Board of Architectural Review

DATE: November 15, 2023
TO: Board of Architectural Review Chair and Members
THROUGH: Jason Sutphin, Community Development Division Chief JDS
FROM: Anna Kohlbrenner, BAR Liaison *AK*
SUBJECT: **Work Session: 10306 Eaton Place – WillowWood**

1. Case Number:	BAR-23-00041
2. Address:	10306 Eaton Place
3. Request:	Mixed-use building
4. Applicant:	Capital City Real Estate LLC
5. Applicant's Representative:	Evan Pritchard
6. Status of Representative:	Attorney
7. Zoning:	CR Commercial Retail, Architectural Control Overlay District

BOARD OF ARCHITECTURAL REVIEW
MAJOR APPLICATION SUBMISSION
CITY OF FAIRFAX

1 SOUTH ELEVATION

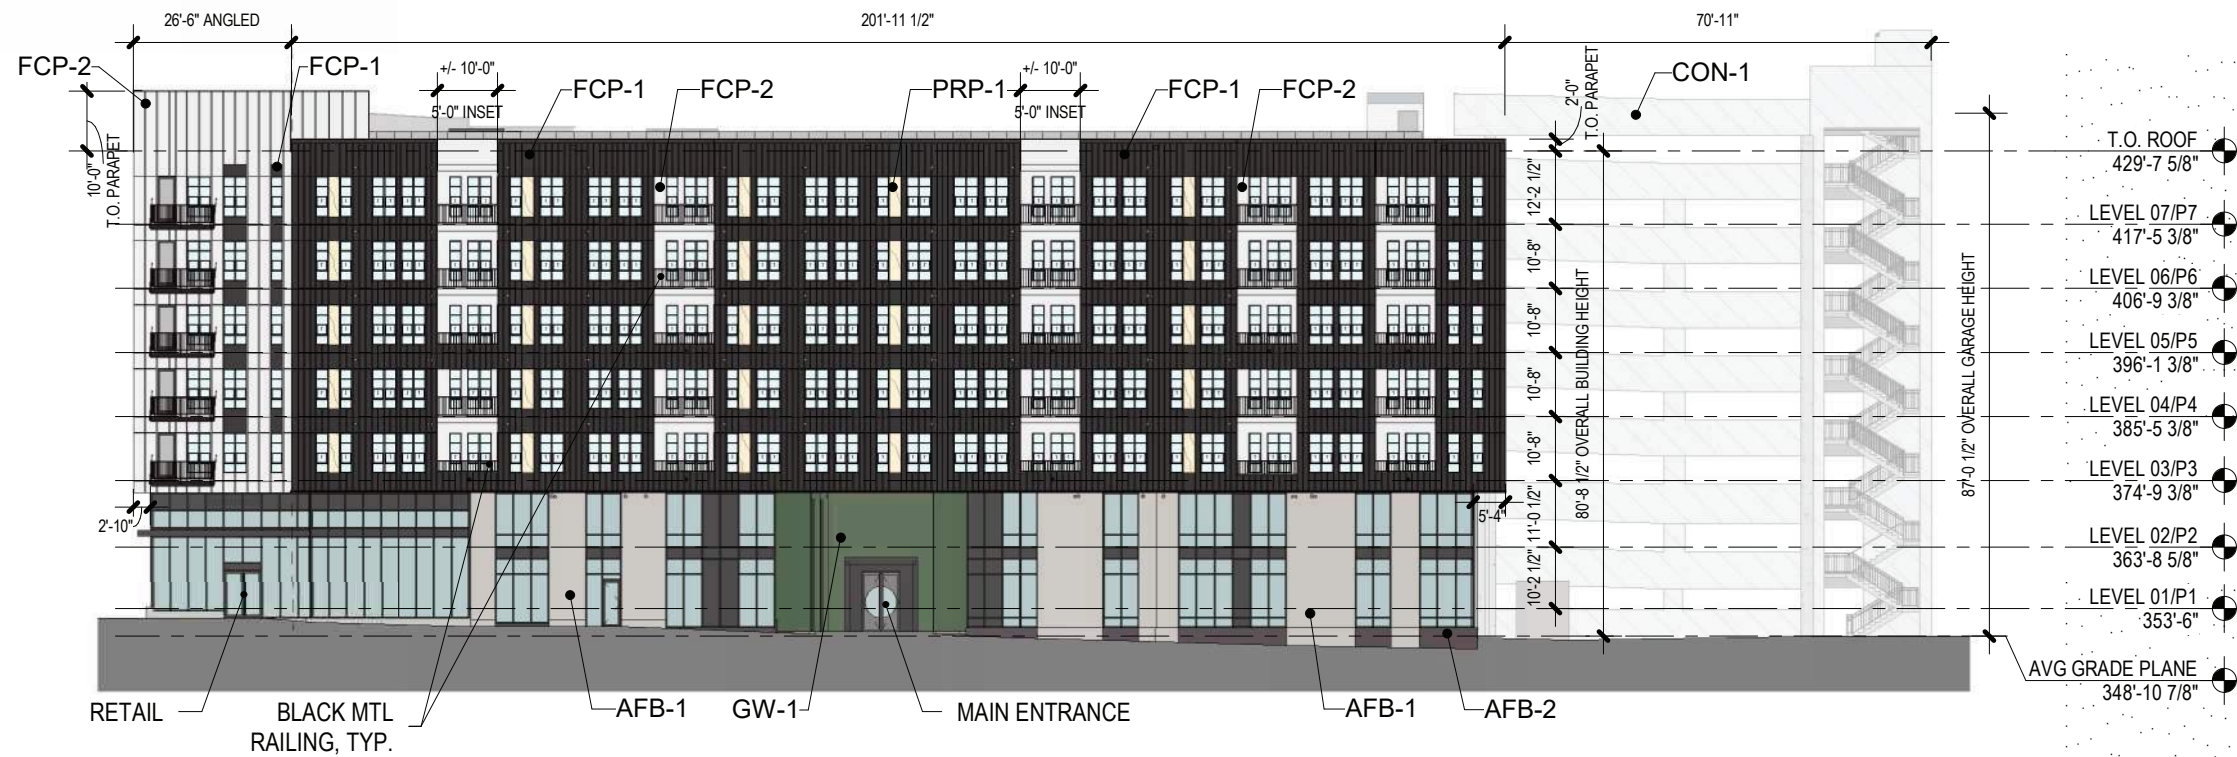
The human scale is not reinforced in this design. The building size appears overwhelming, without a change in material at the pedestrian realm. The building width along the east side is approximately 275' wall of fiber cement panel with little to no windows and a precast concrete parking garage, which does not engage pedestrians or drivers in any way. Portions of the parking garage are visible from Eaton Place. The applicant shall look at treatments to screen it. The building width along the west side is approximately 300', not including the parking garage section, which is a long wall of repetitive windows and fiber cement material and some brick from the first to second story. The western building wall shows repetitive utilitarian balconies. The building scale along Eaton place shows repetitive windows, with little character and sense of place.

The applicant is not proposing a different foundation material on the east and west sides of the building. Staff recommends using separate foundation material on east and west sides as well, in addition to continuing a different color brick or material along Eaton at the foundation line.

The applicant is proposing brick on the west and south sides of the building but only up to the second floor. The east side of the building does not have brick, only fiber cement and concrete. The applicant shall add varying material bays throughout while adding more masonry material.

1 N-S SIGHTLINE SECTION TO FAIRFAX BLVD

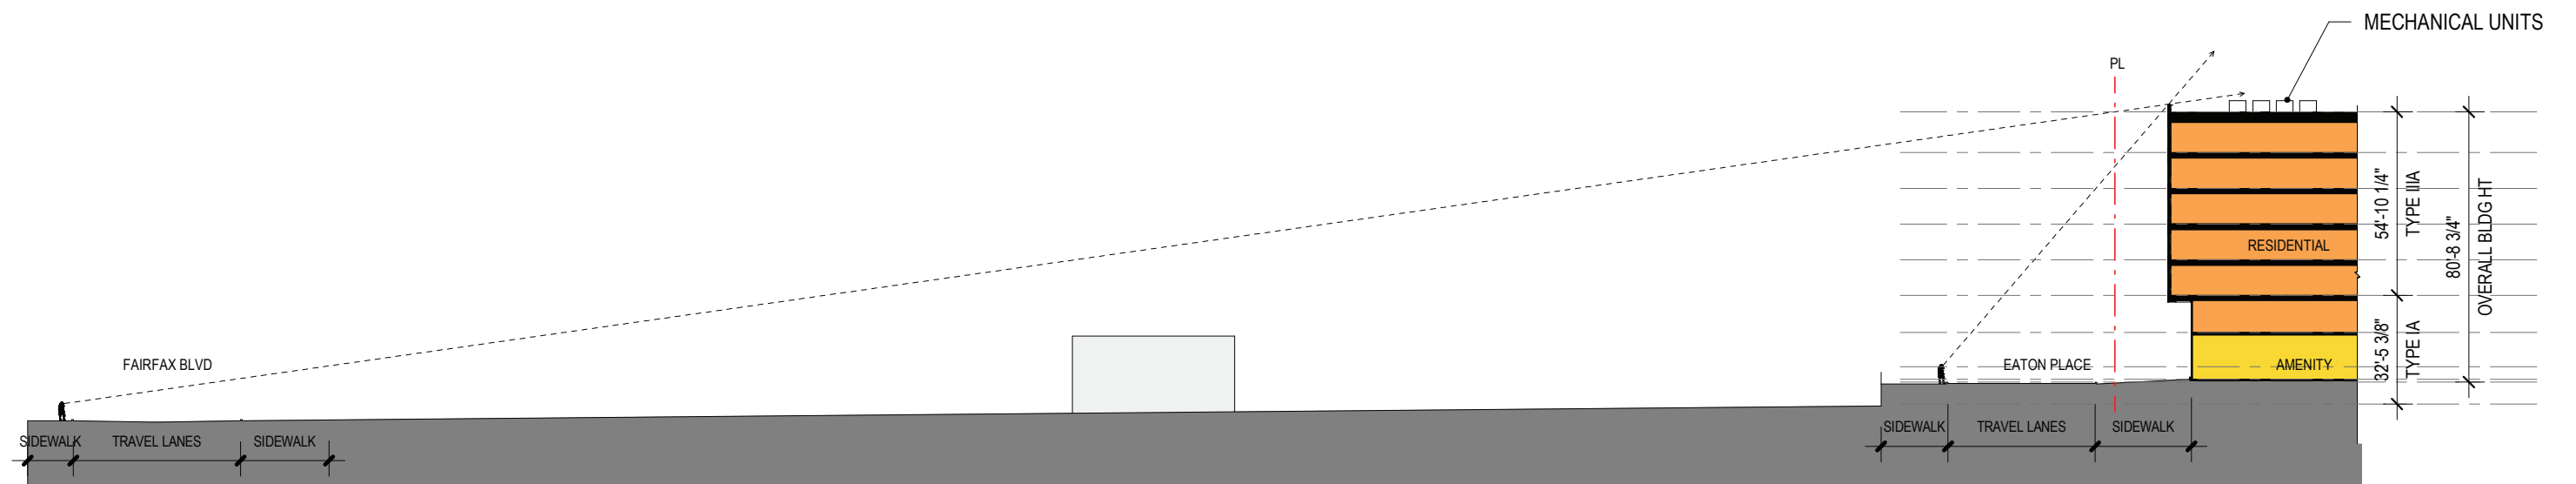
Mechanical equipment would be located on the rooftop and would not be visible, according to submitted site line diagram. Would need to be hidden from Fairfax Blvd as well, as this building adds to the skyline of Northfax.
